Re: Petition for Rule Making
Amendment of DTV Table of Allotments
KCFG-DT
Flagstaff, Arizona

SUPPLEMENT TO PETITION FOR RULE MAKING

ENGINEERING STATEMENT

Exhibit I

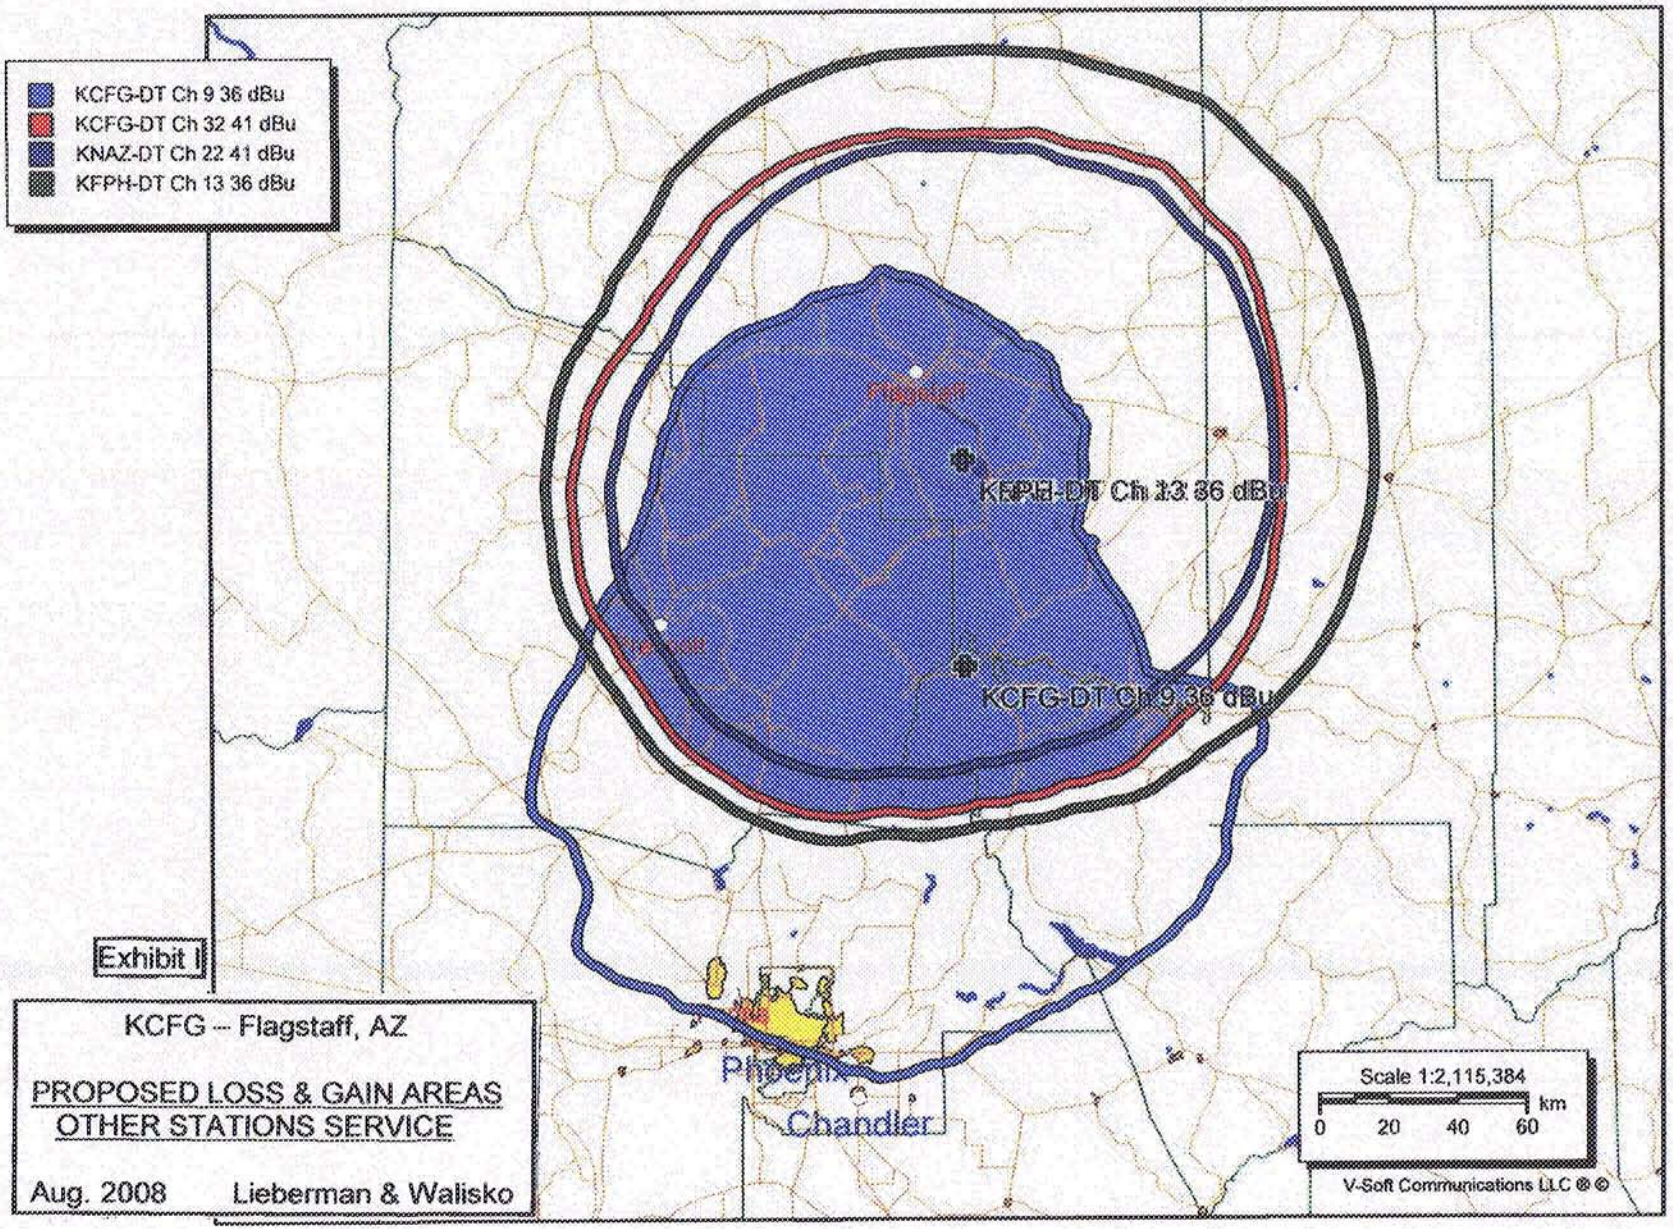
1. Provide a color map showing the before and after signal contours depicted so the loss area may be seen. A map as requested is provided in Exhibit I. It clearly shows the loss area, the gain area and the common area. The KNAZ contour depicted herein is the same for the channel 2 analog contour and the proposed channel 22 digital contour at 283 kW.

2. A depiction of the other stations that will serve the loss area. Exhibit I also furnishes a reply to this question.

3. As shown in Exhibit II, the population in the loss area is 5920 people who will continue to receive service from KNAZ and KFPH as shown in Exhibit I. The number 5920 is obtained by subtracting the population within the overlap area from the total population within the channel 32 area of KCFG.

The area in question will still continue to be served by the other two Flagstaff stations, KNAZ and KFPH. The instant station, KCFG, is not a network station so a loss of network service by the 5920 people will not be had.

Exhibit III-A

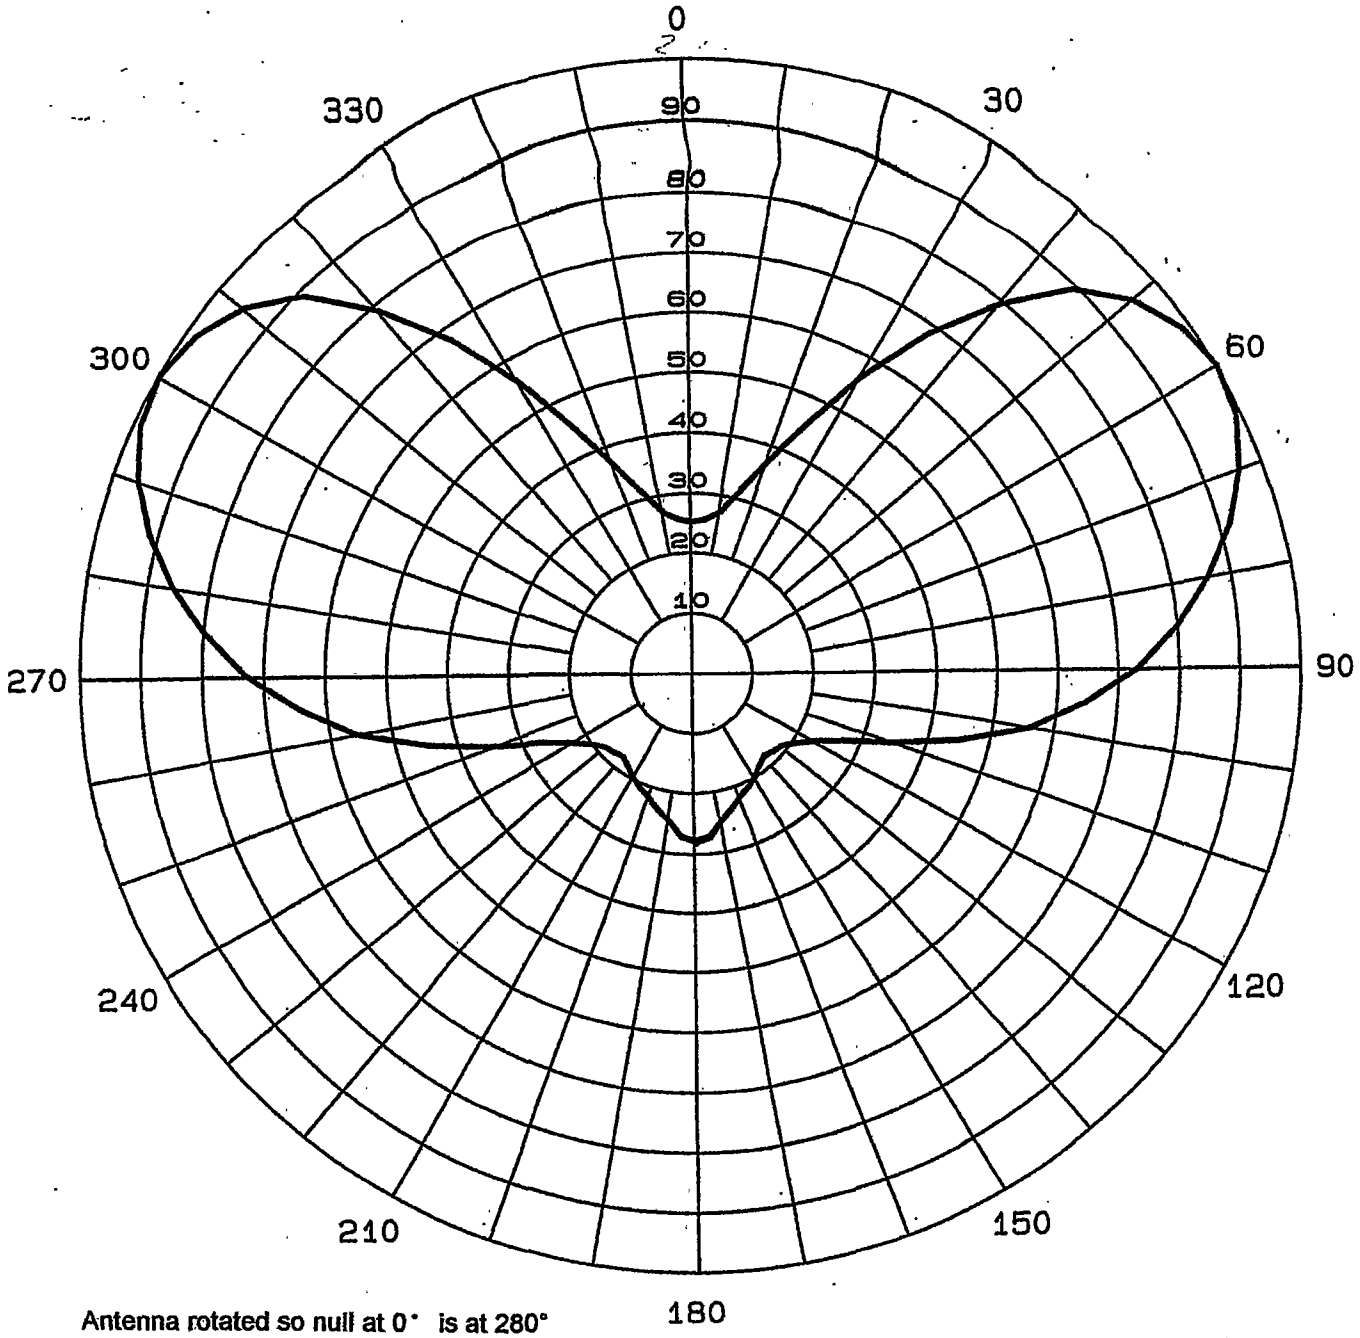
The Staff raised an interference issue with co-channel KGUN, Tucson, AZ. That has been corrected by the judicious use of a directional antenna. That pattern and associated tabulated data are included here to eliminate any ambiguity about the rotation of the pattern. A discussion was had with the Staff about the confusion and for the purpose of clarifying the matter, the pattern as depicted herein is not rotated. In use the pattern would be rotated so the null at N 0° E would appear at N 280° E. This non-rotated pattern is shown as Exhibit III-A. The tabulated data depicted in Exhibit III-B has the data listed in the rotated mode.

Employing a directional antenna reduces the caused-to-interference to KGUN from the instant proposed to 0.1%. Thus

the combined interference to KGUN from all sources is under 0.5%
